NOTICE OF MEETING
PLANNING AND ZONING COMMISSION
6:00 P.M. – August 11, 2022

PLANNING AND ZONING COMMISSION ITEM:
PC-22-11
FINAL PLAT
BULVERDE RV PARK

PLANNING AND ZONING COMMISSION ITEM:

PLANNING AND ZONING COMMISSION ITEM:
PC-22-23

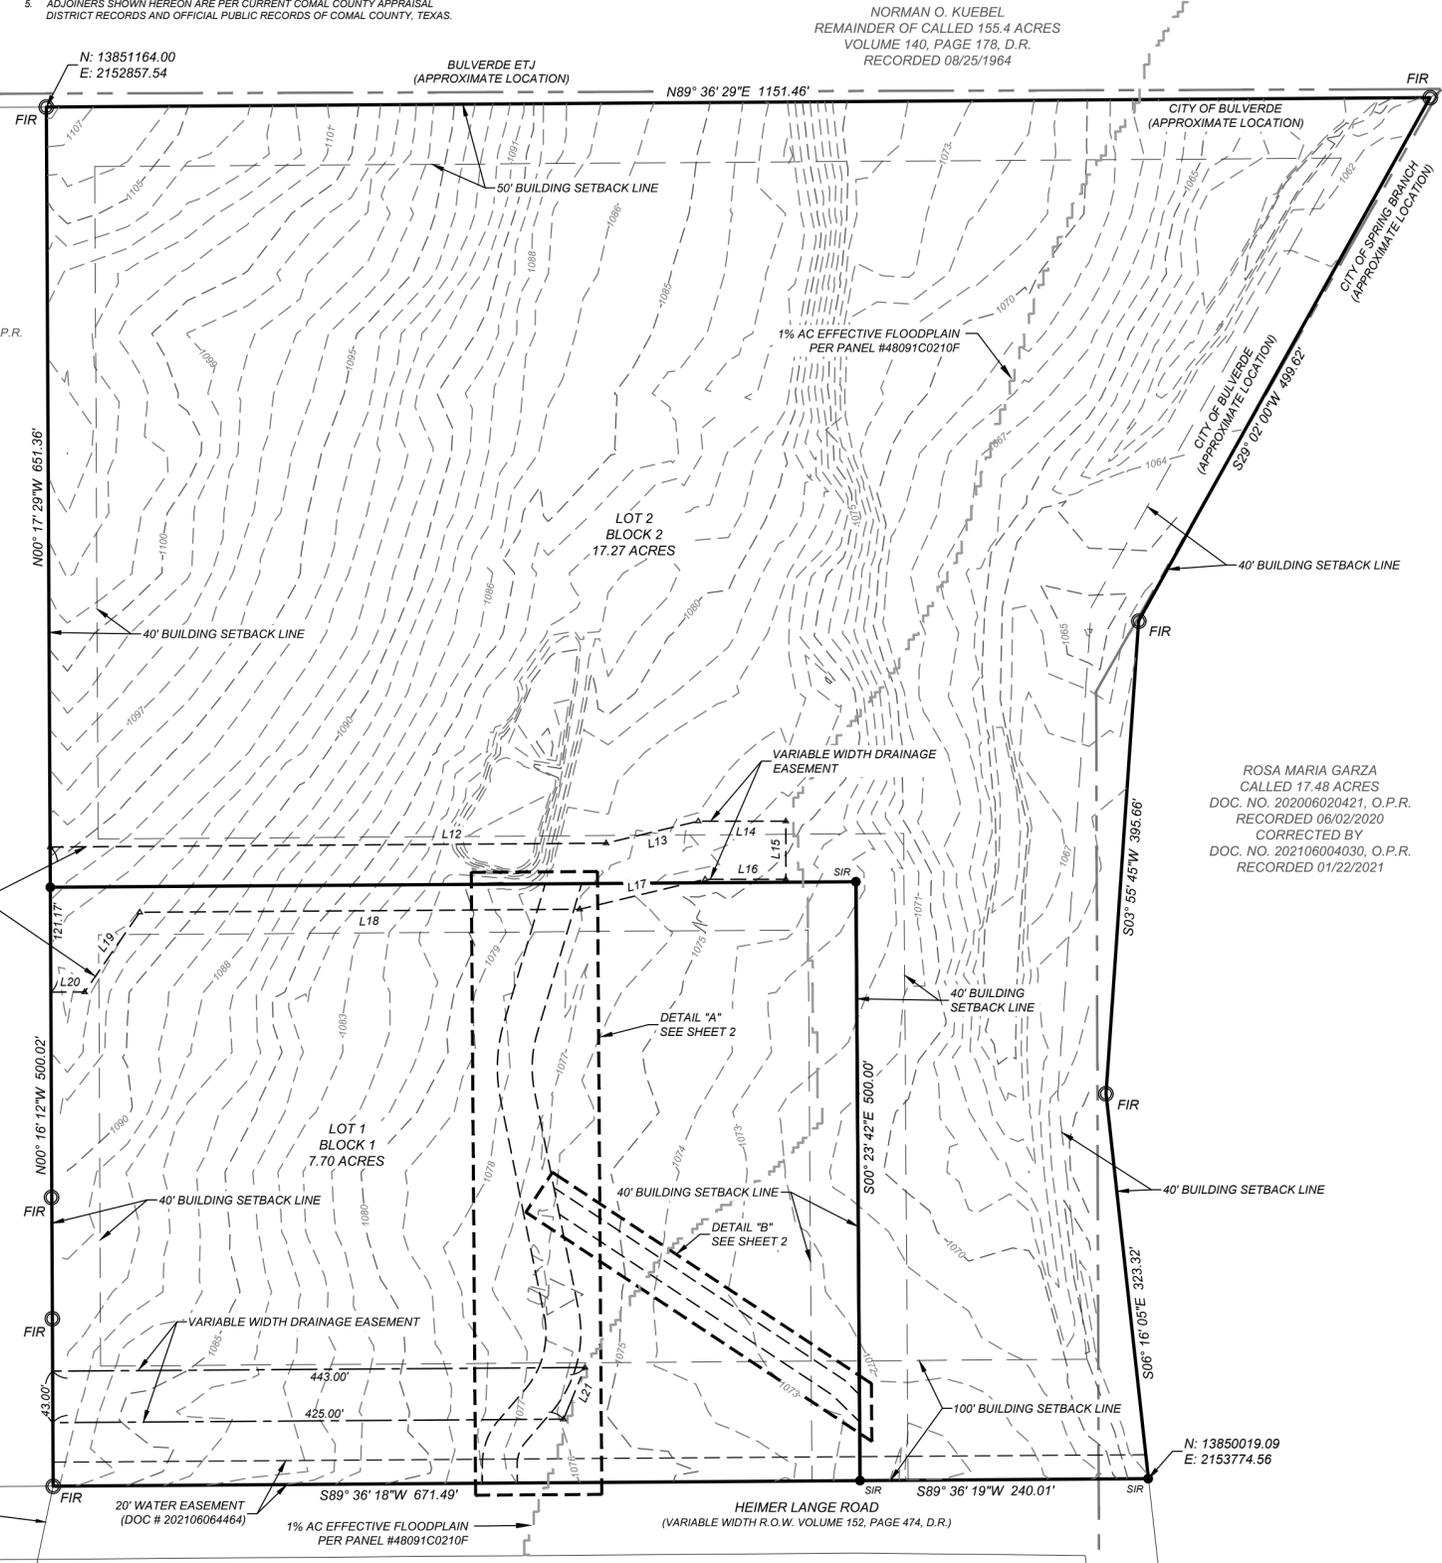
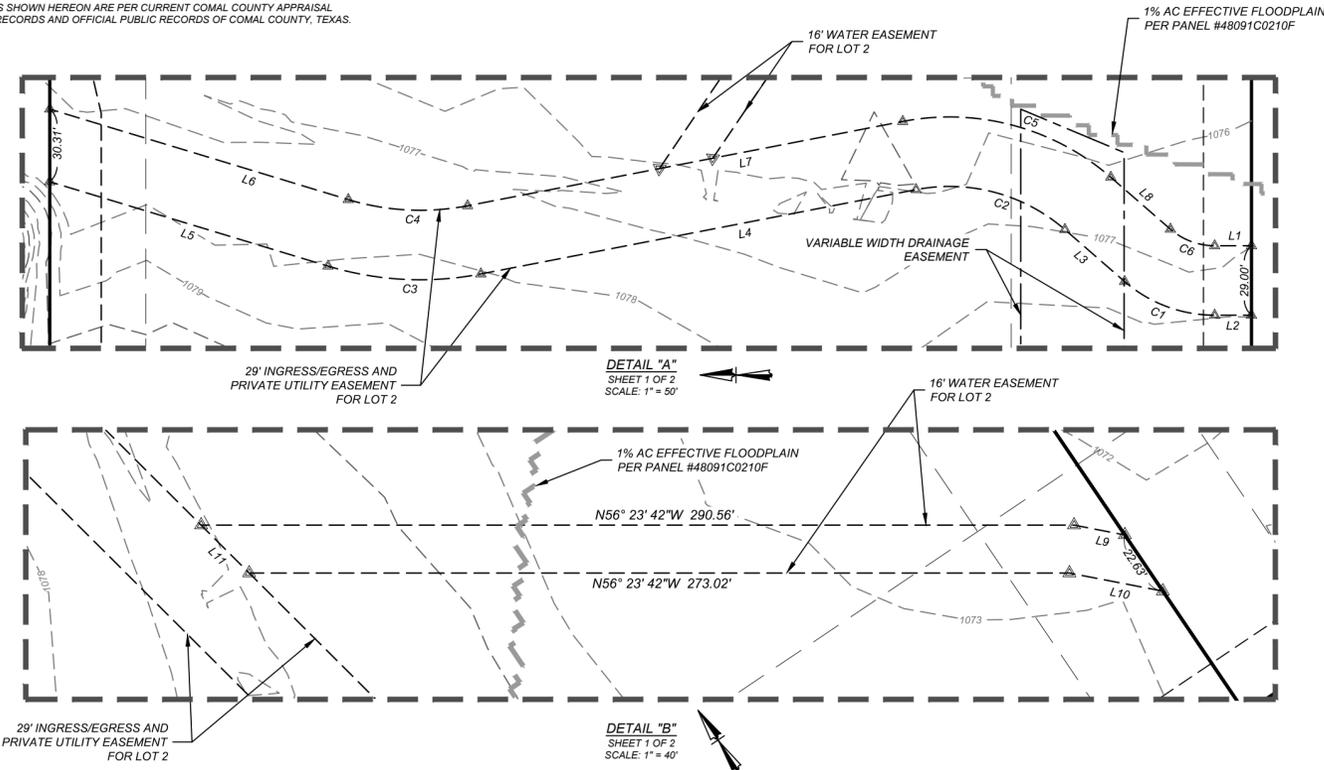
1. Plat should be labeled "Subdivision Plat" not "Development Plat." – **Comment resolved.**
2. Provide Lienholder address and certification on plat. – **Comment resolved.**
3. Provide Planning Director signature block similar to: – **Comment resolved.**

5. Label lots with "Lot 1, Block 1" and "Lot 2, Block 2." – [Comment resolved](#).
6. Provide bearing and distance dimension from a corner of the subdivision to a corner of the original tract or original survey. – [Comment resolved](#).

7. Building setback lines must be shown per section 2.03(c) of the subdivision ordinance. – [Comment resolved](#).
8. Show City limits lines on vicinity map and plat. – [Comment resolved](#).

9. Plat Note #2 states that there is no FEMA floodplain on-site. Correct this. – [Comment resolved](#).
10. Surveyor Note #5 should reference Comal County. – [Comment resolved](#).

11. Provide Slope Map and any applicable easements required by Section 1.05(b)(ii)(24) and Section 4.04. – [Comment resolved](#).
12. Add note to plat stating maximum impervious cover, matching TCEQ approval letter. – [Comment resolved](#).

13. Access easement required if the only point of access for Lot 2 is through Lot 1. – [Comment resolved](#).

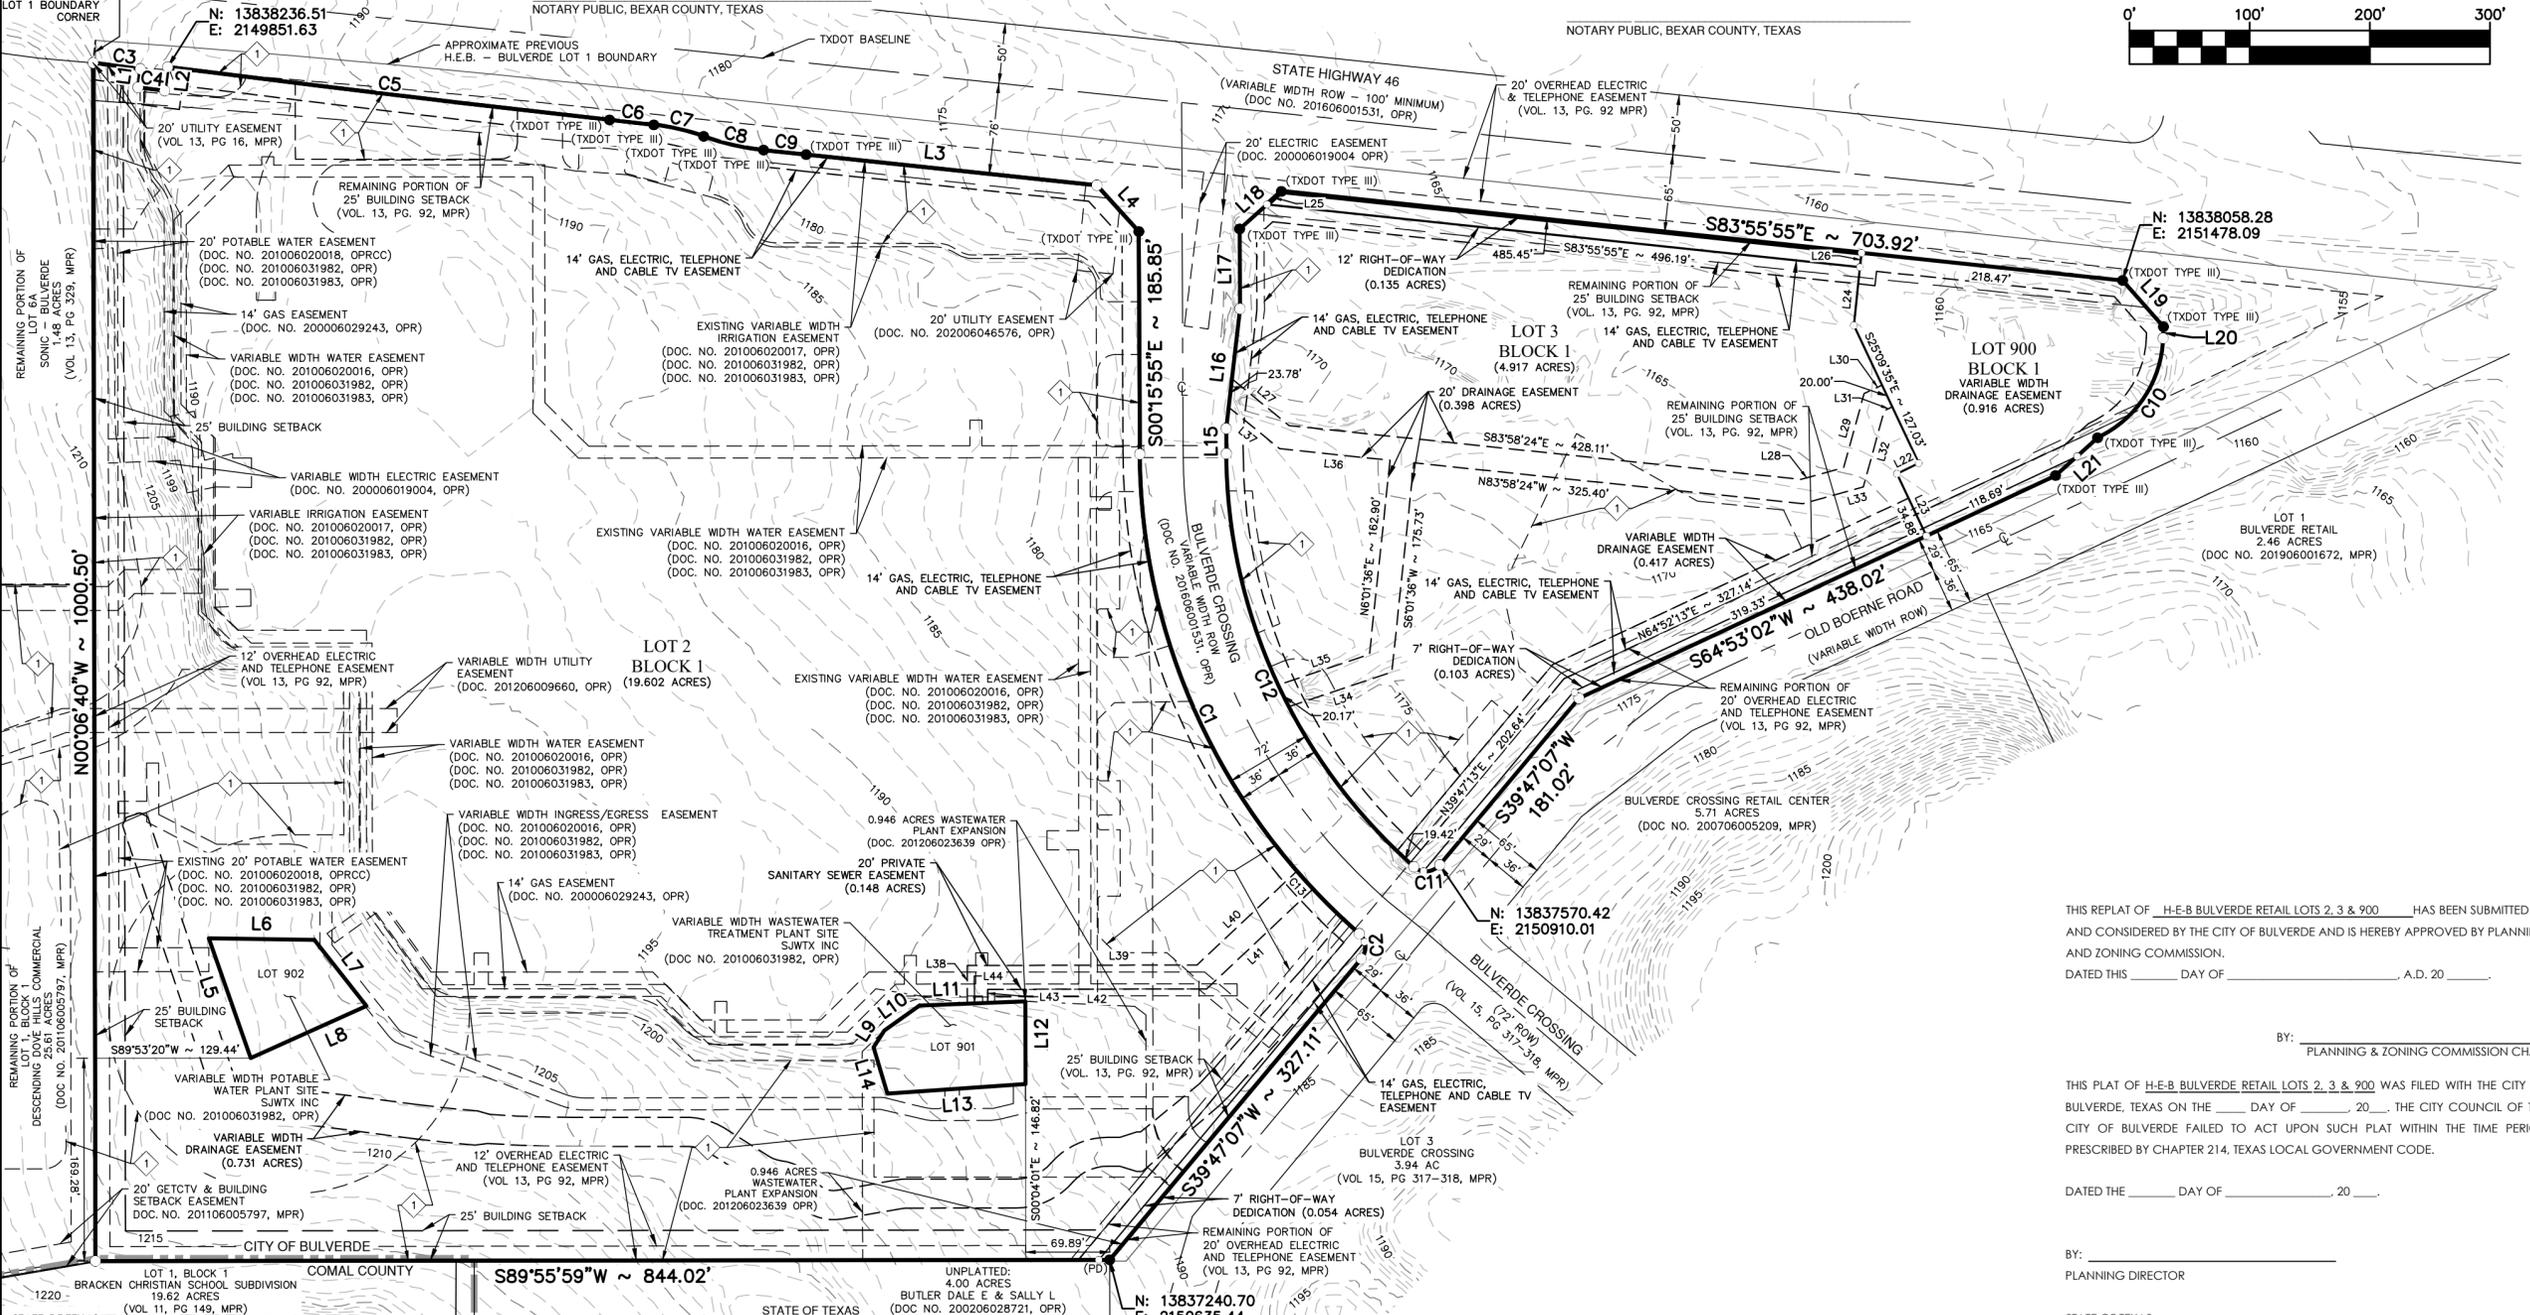
1. Add owner/notary blocks for SJWTX, Inc, as an owner or property within the subdivision [Sec. 1.05(b)(ii)(5)]. [6/27 – Comment resolved.](#)
2. Verify correct county where signature is taking place is used in signature blocks or use a blank “ _____ ” to fill in at the time of signature. [6/27 – Comment resolved.](#)
3. Correct Surveyor signature block with extra “I” at the very beginning. [6/27 – Comment resolved.](#)
4. Remove the “Attest” line on the Planning & Zoning signature block and add the planning director signature block using the wording below: [6/27 – Comment resolved.](#)

5. The City’s Master Thoroughfare Plan indicates Old Boerne Road as a collector requiring 72-ft of right-of-way. Where the existing right-of-way is not sufficient, the subdivision must make a dedication to attain 36-ft of right-of-way on the north side of the centerline or a minimum of 72-ft total width. [6/27 – Comment resolved.](#)

6. A drainage easement should be provided for the open channel across the southern end of Lot 2, conveying off-site water through the subdivision [Sec. 1.05(b)(ii)(10)]. *6/27 – The provided drainage easement should be located by bearings and distances and needs to meet the requirements of Sec. 2.03(d)(iv)(1).* *7/21 – Comment resolved.*
7. Provide a bearing and distance dimension from a corner of the subdivision to a corner of the original tract or original survey [Sec. 1.05(b)(ii)(14)]. *6/27 – Comment resolved.*
8. Adjoining ownership information should include property acreage [Sec. 1.05(b)(ii)(21)]. *6/27 – Comment resolved.*
